**Addendum No. 3**

**Final Environmental Impact Report  
for Metro Gold Line Foothill Extension - Azusa  
to Montclair (SCH 2010121069)**

**Evaluating Minor Design Changes of the Project  
Azusa to Montclair**

Metro Gold Line Foothill Extension Construction Authority  
March 2016

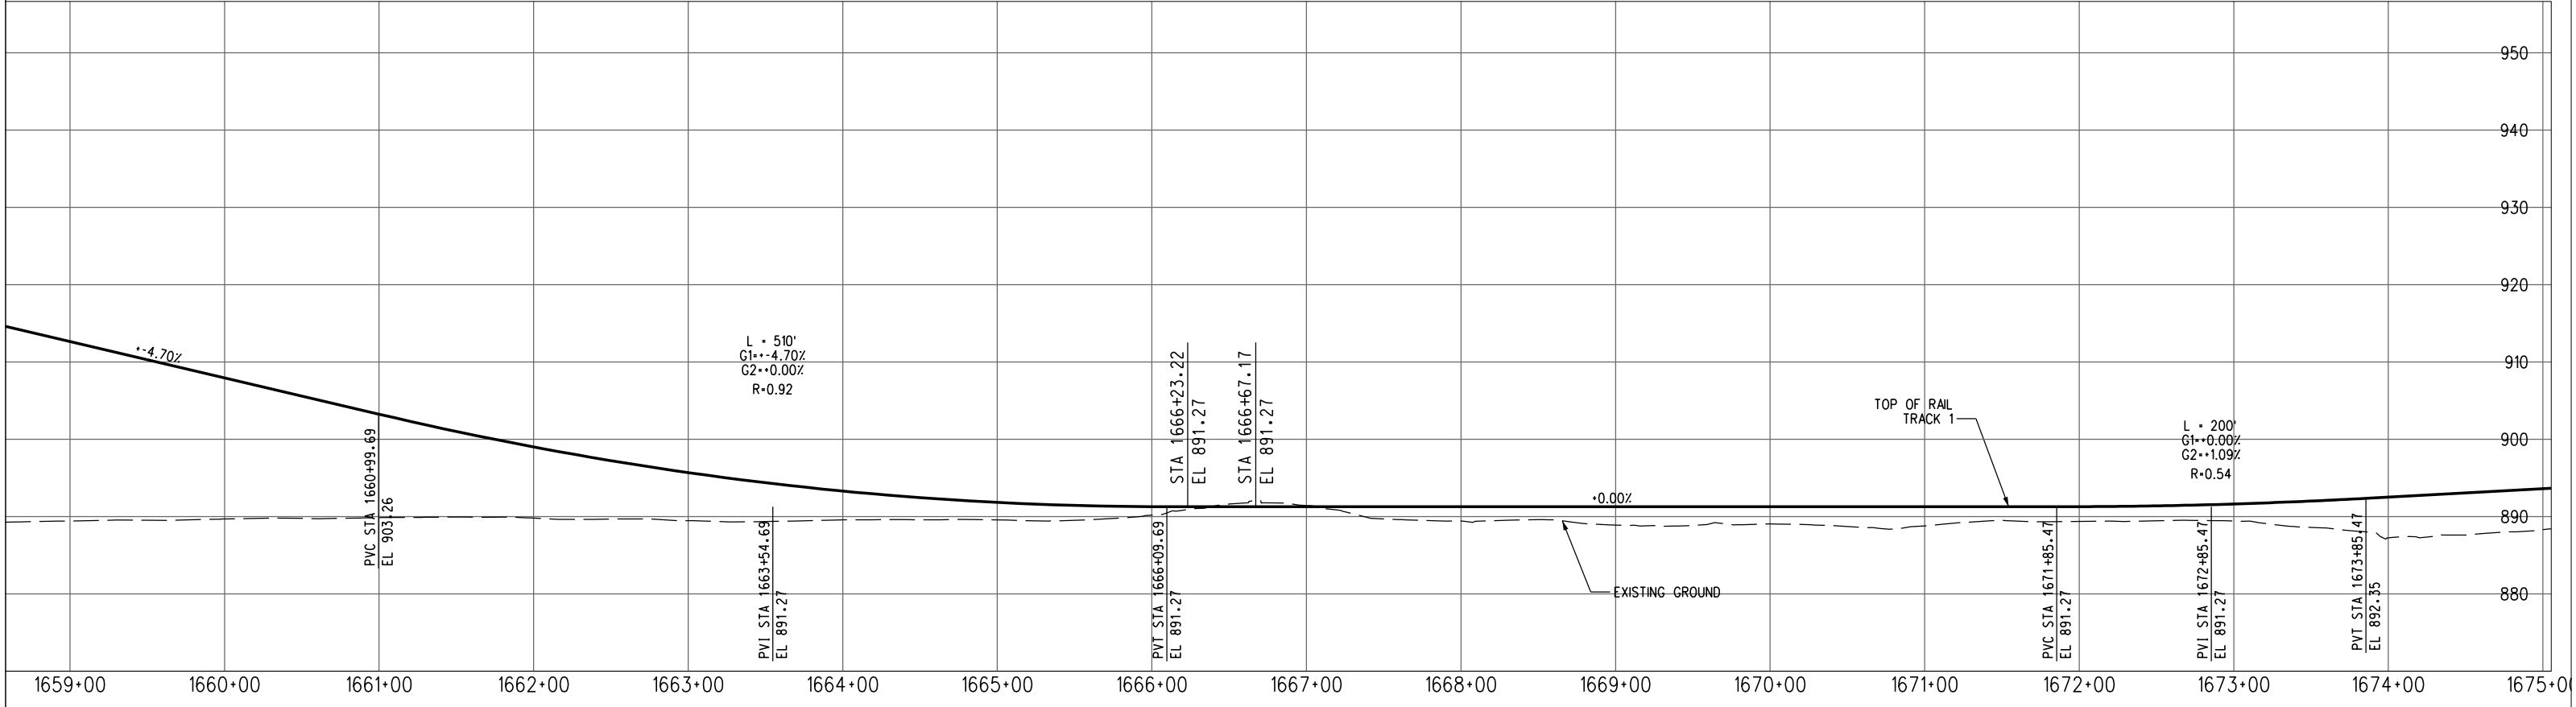
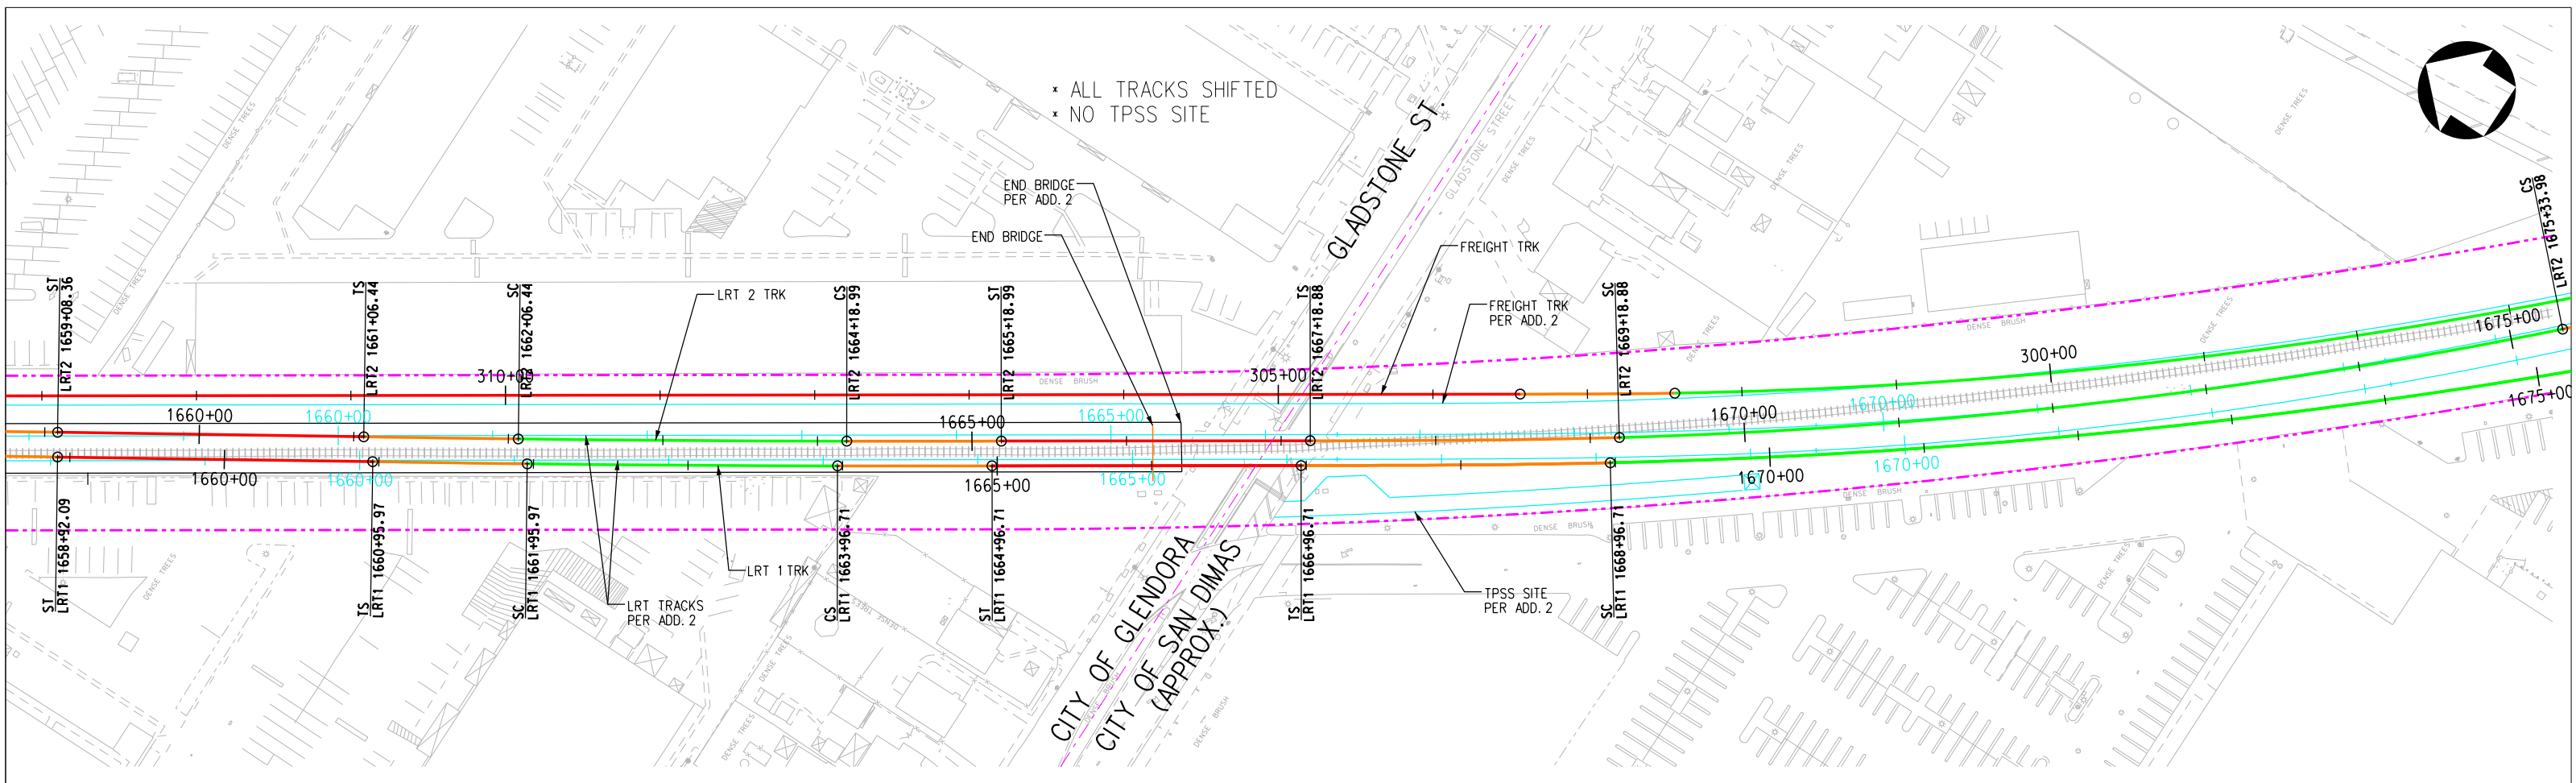
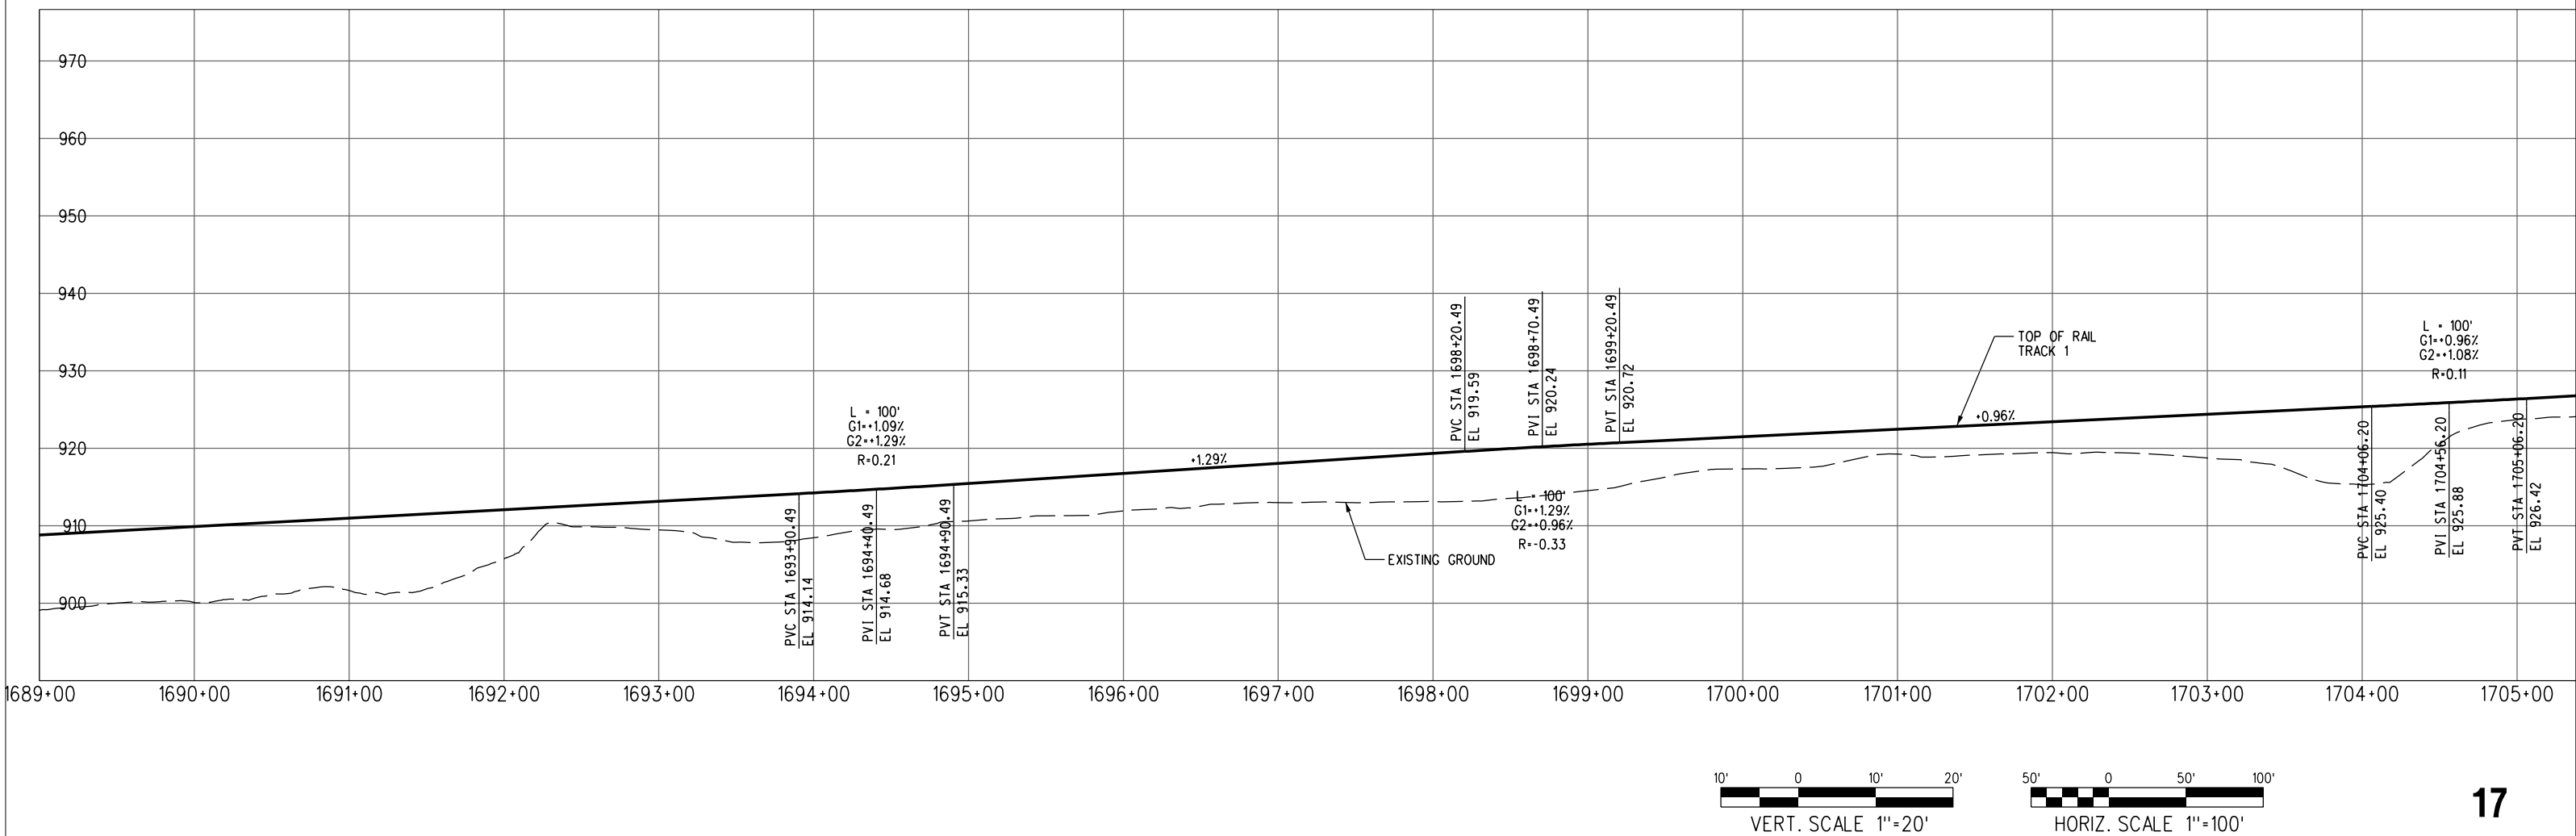
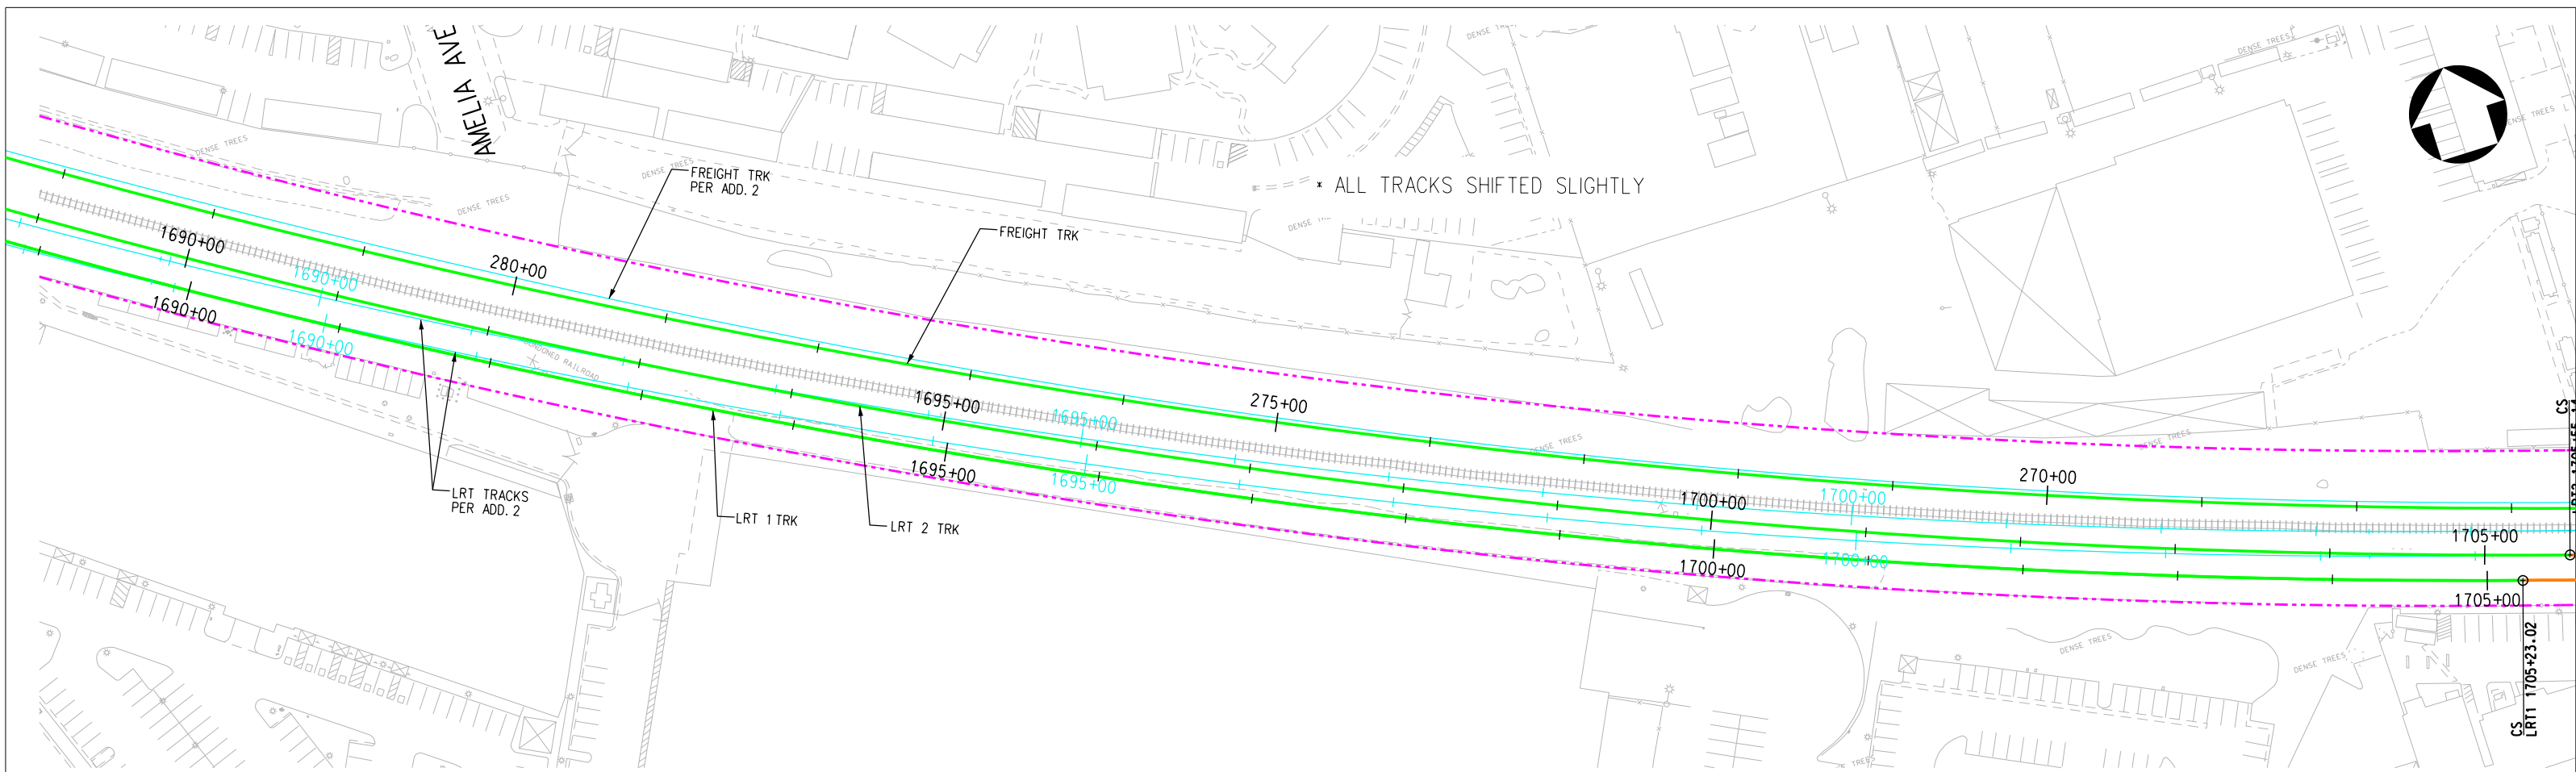
\* ALL TRACKS SHIFTED  
 \* NO TPSS SITE
